# CITY OF ALBUQUERQUE

July 9, 2024

**RE: Event Center  
1611 Airtech Ct. SE  
Grading and Drainage Plans  
Engineer's Stamp Date:06/20/24  
Hydrology File: N15D017**

**RE: Event Center  
1611 Airtech CT. SE  
Comments dated May 28, 2024  
Hydrology File: N15D017**

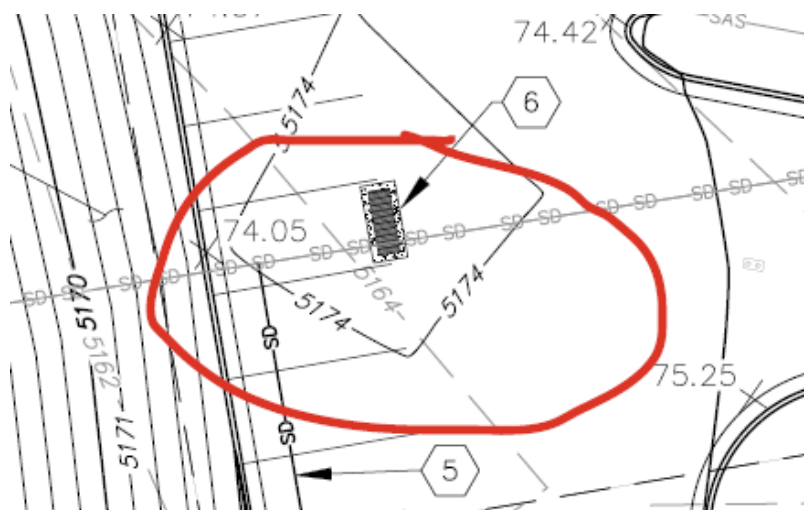
1. The constructability with the Type D inlet along with the 18-in storm drain connecting to the existing 60-in pipe. This should a manhole with a grate top?? Please clarify the design.

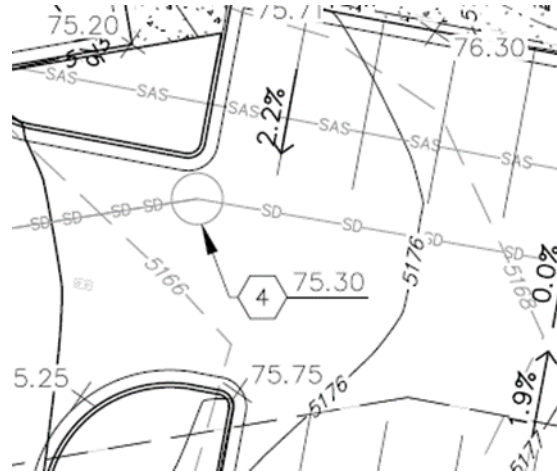
2. I would highly recommend that the existing manhole rim elevation be topo'd along with the inverts of the 60-in storm sewer.

3. Also looking at the as-builts and the amount of fill that is being brought in on top of the existing 60-inch RCP Class III. This will have to be replaced with a 60-inch RCP Class IV due the cover and original installation. Please specify the limits of this existing storm sewer that will need to be changed to Class IV.
4. As discussed with the City Engineer, Shahab Biazar, please provide written proof from a structural engineer that the retaining walls as designed will be buildable and will not create safety issues with the adjacent property. There is limit space for compaction.

PROJECT NO.	DATE	BY
24001		
DESIGNED BY:		RJF
DRAWN BY:		JB
CHECKED BY:		RJF
DATE:	JUNE 2024	
SHEET TITLE		
<b>GRADING PLAN</b>		
SHEET NO.		
<b>C-1</b>

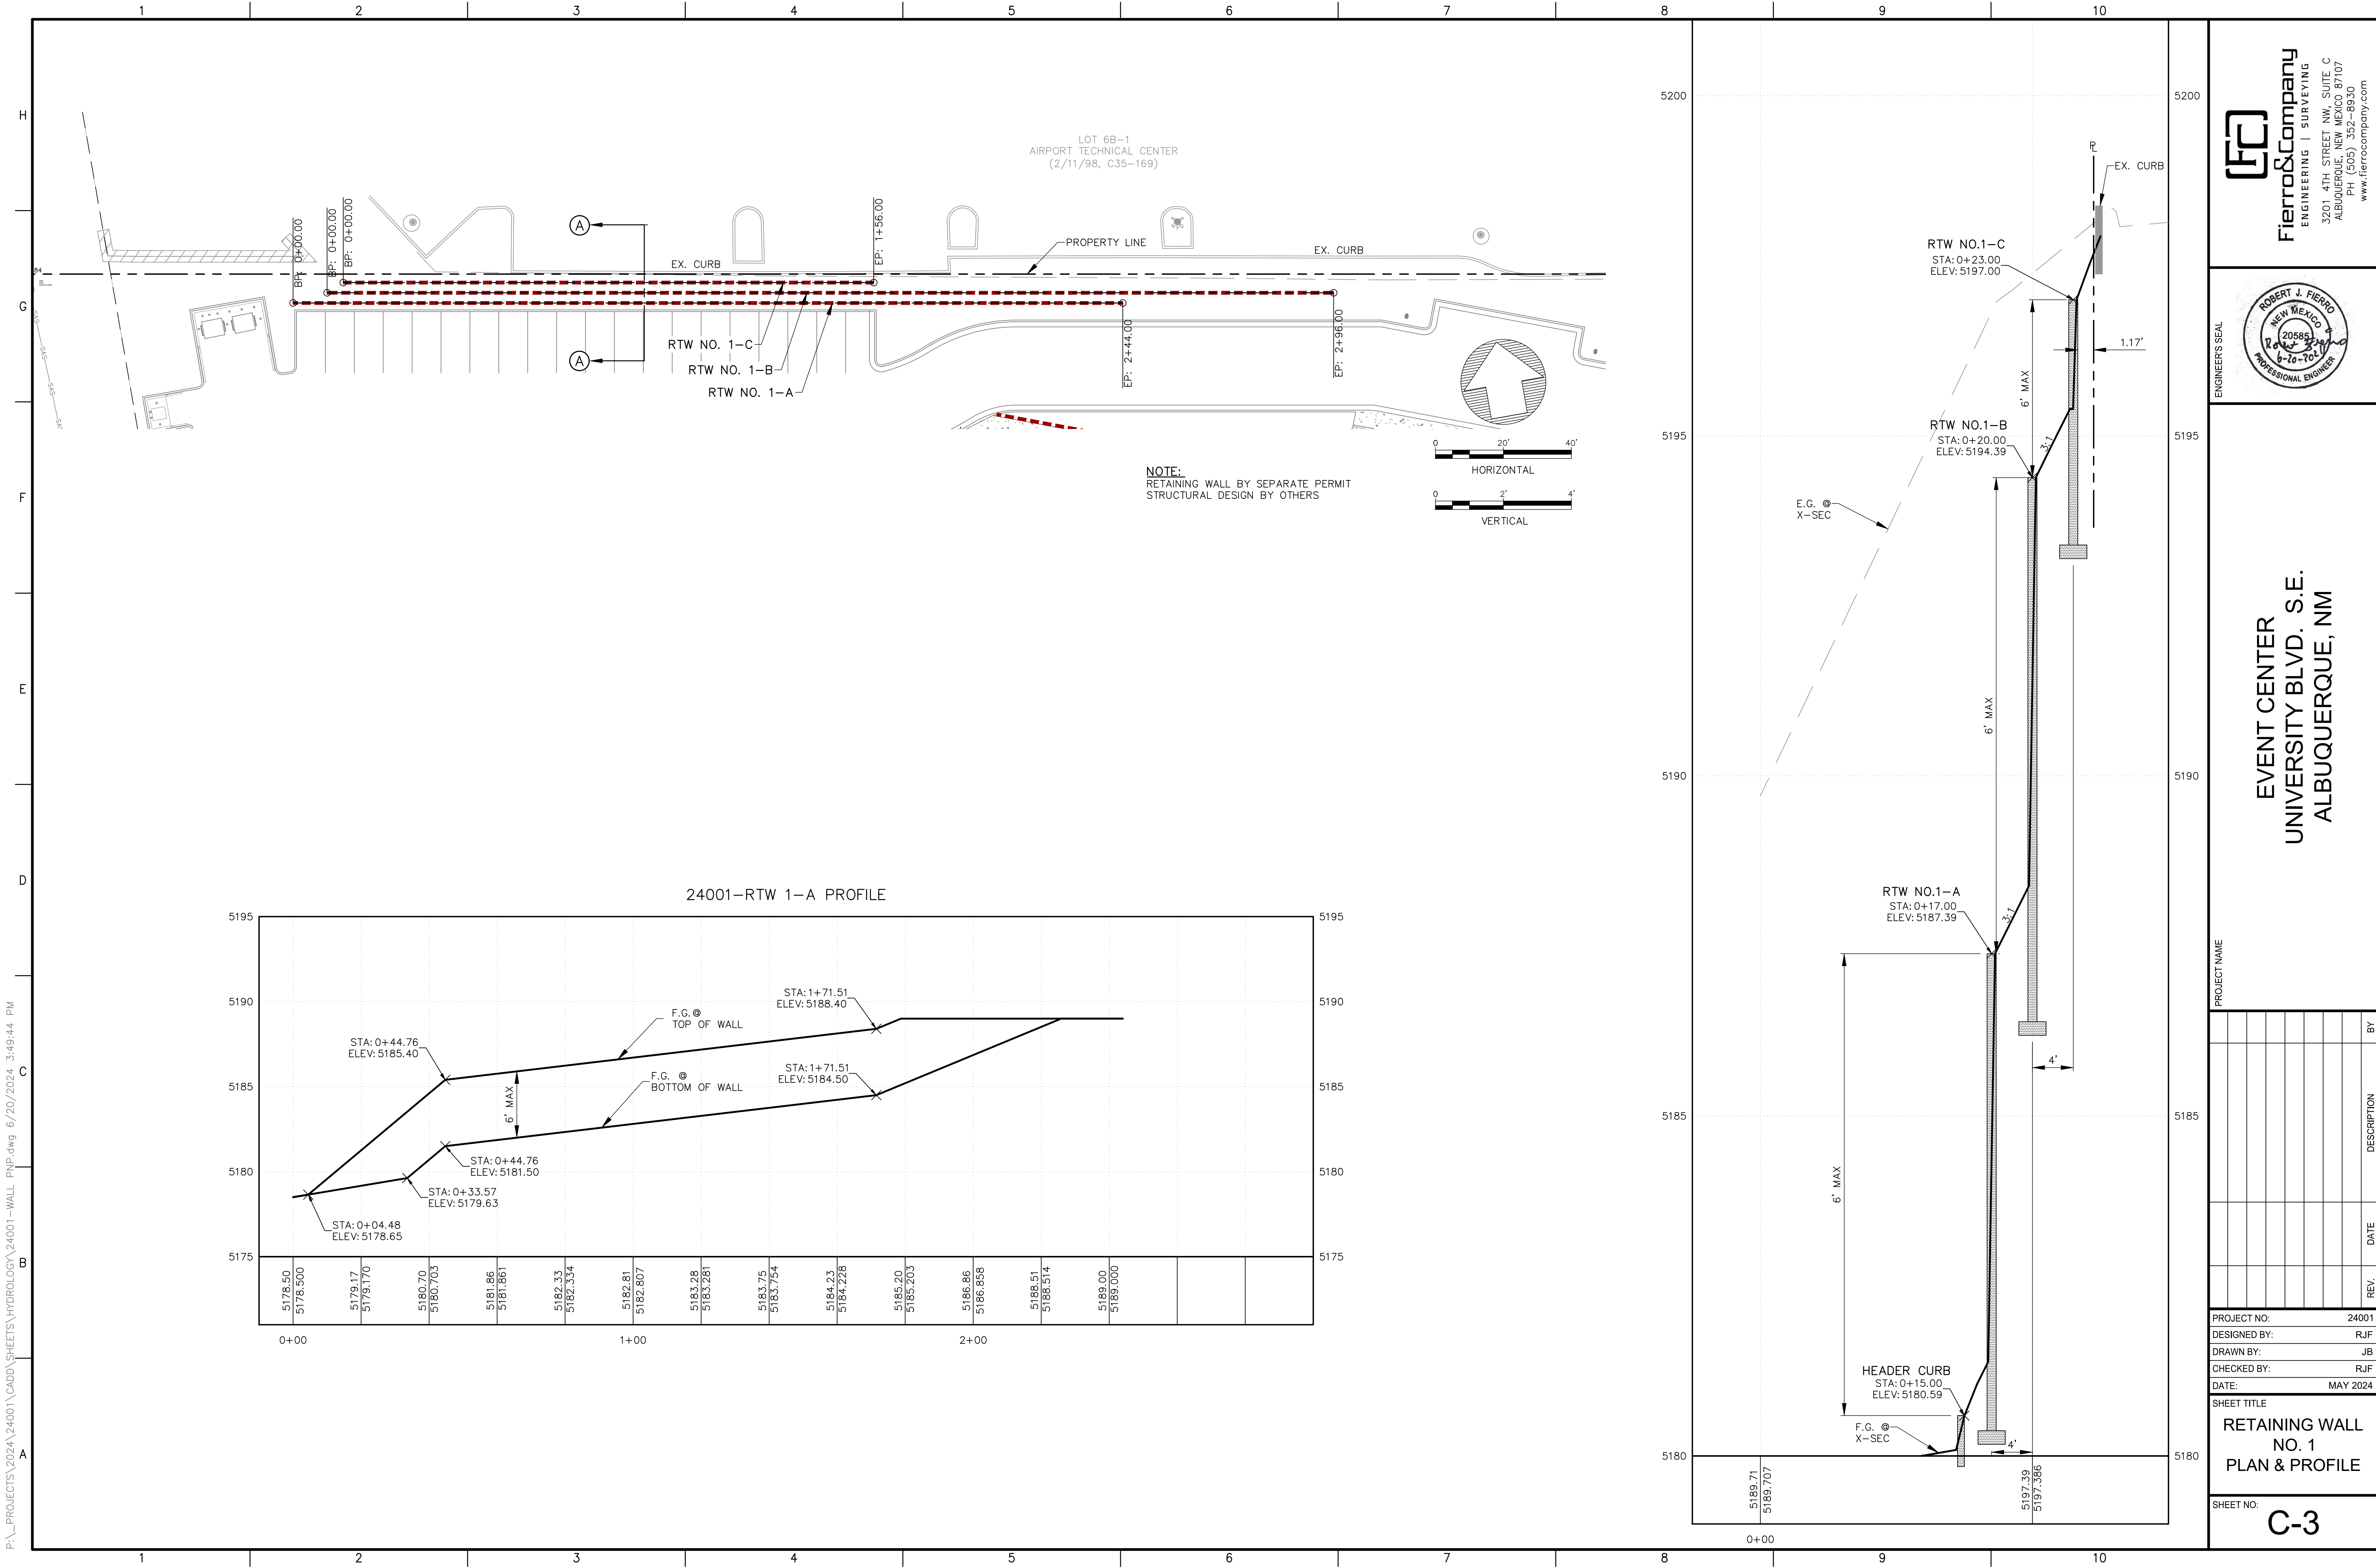
**Comment 2:** The Type E manhole needs to be at the existing 60-in pipe and not off to the side as shown. Any private inlet can also be tied into the manhole.

**Comment No. 3:** Please note that the above Type E manhole will have to be placed on a Work Order since it is within a City Public Drainage Easement.

**Comment No. 4:** Please note that adjusting the elevation to the existing manhole will also be required to be included in the Work Order since this is more than a simple adjustment. It appears that it will have to be moved up about 10 feet.

**Comment No. 5:** I would highly recommend that the existing manhole rim elevation be topo'd along with the inverts of the 60-in storm sewer.

**Comment No. 6:** Also looking at the as-builts and the amount of fill that is being brought in on top of the existing 60-inch RCP Class III. This will have to be replaced with a 60-inch RCP Class IV due the cover and original installation.

**Comment No. 7:** The proposed grades in the rear are not 3:1, therefore please add a note under Grading Notes. “Side slopes need to be stabilized with Native Grass Seed (per City Spec 1012) with Aggregate Mulch or equal (Must satisfy the “Final Stabilization criteria” CGP 2.2.14.b.)”.

➤ Response: A city work order is required since a public storm drain is being constructed with this project. The private inlet connection will be shown on the public work order construction plans.

➤ Response: Note added.

➤ Response: See response under Comment No. 3.

➤ Response: Fierro & Company surveyed the outlet of the 60-inch RCP located on the Golf Course property on 6/18/2024. Using asbuilt information such as the slope. The elevation for the existing 60-inch pipe was established. A note was added to field verify existing inverts.

- Response: Any pipe segments that will need to be replaced to RCP Class IV will be shown on the City Work Order Construction Plan Set.

- Response: Note added.
